UNITED STATES PATENT AND TRADEMARK OFFICE

APPLICATION NO.	FILING DATE	FIRST NAMED INVENTOR	ATTORNEY DOCKET NO.	CONFIRMATION NO.
10/755,494	01/12/2004	William D. McKay	RBD-120-A	1986
22440	7590	06/28/2005	EXAMINER	
GOTTLIEB RACKMAN & REISMAN PC 270 MADISON AVENUE 8TH FLOOR NEW YORK, NY 100160601			BALSIS, SHAY L	
			ART UNIT	PAPER NUMBER
			1744

Office Action Summary

DETAILED ACTION

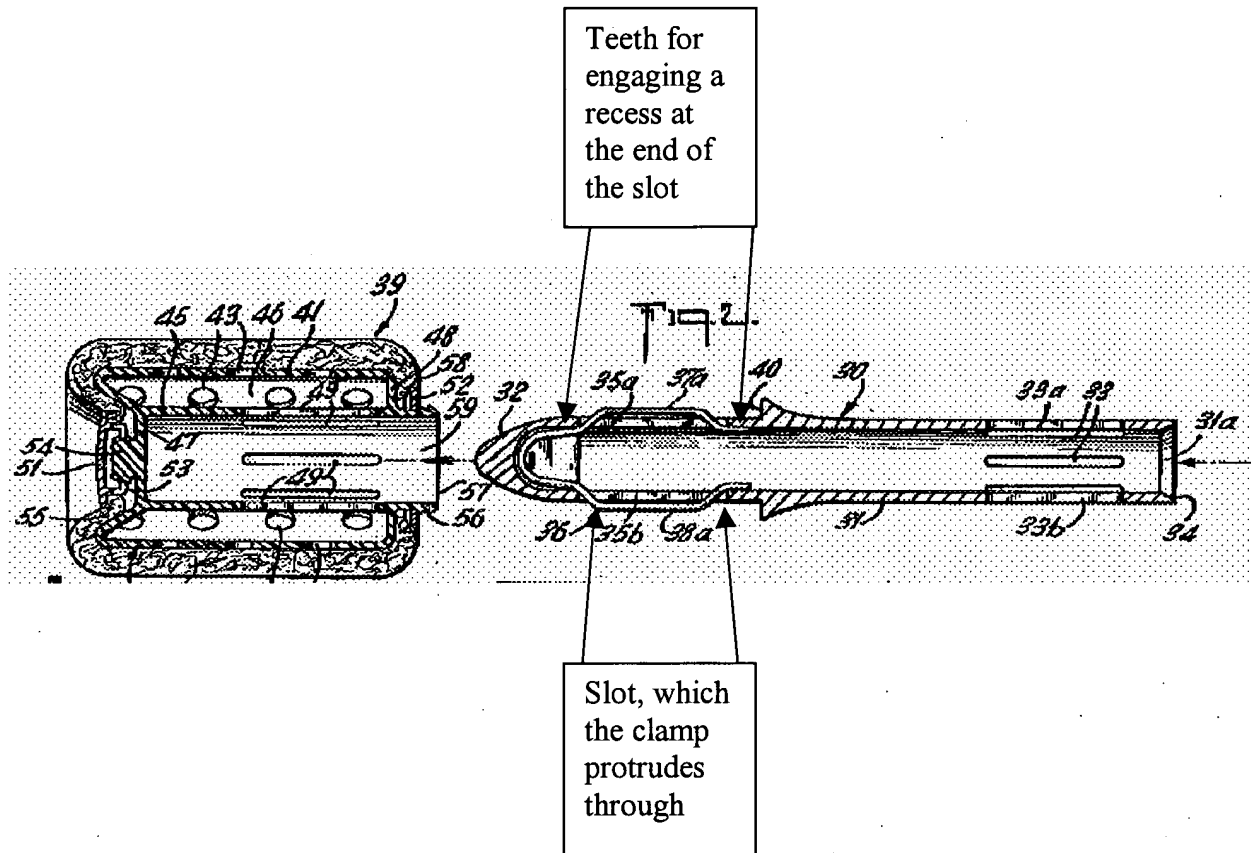
Teren teaches a cleaning apparatus comprising a cleaning element support (30) for carrying the cleaning element (39) about a sidewall of the support. The support is cylindrical. There is a handle (15) coupled to the support wherein the handle is rotatably coupled to the support. There is a powered drive means (not labeled) carried in the handle having a rotatable output shaft for rotating the support upon activation of the power drive means. There is a clamp means (36) on the support for clamping the cleaning element in a fixed position on the support. There is a slot formed along the support for receiving the clamp means (see figure below). The cleaning element has an exterior surface (41) with cleaning members (42) fixed thereto and radially projecting therefrom. The opposed ends of the cleaning element are spaced apart from each other when the cleaning element is mounted on the support. The cleaning element extends over substantially an entire surface of the support. There is a container (46), which defines the support, for carrying fluid and apertures are formed in the container for dispensing the fluid from

the container. The clamp means comprises a first and second end (see figure below) for selectively engaging recesses formed at either end of the support slot.

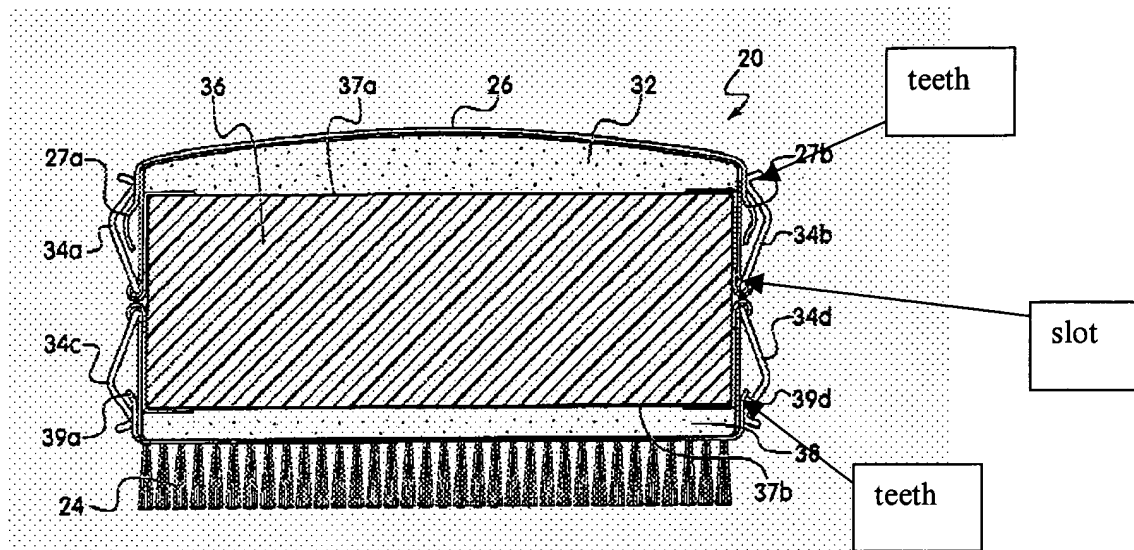
Applicant's arguments filed 5/9/05, with respect to Teren, have been fully considered but they are not persuasive. Examiner notes that the cleaning member (39) in Teren includes the scouring pad (42) and the tool member (44). On figure 2, the cleaning member is the entire drawing on the left side of the figure. The support member is indicated as reference number 30. Therefore the clamps are located on the support member and are used to secure the cleaning member (scouring pad and tool member) to the support.
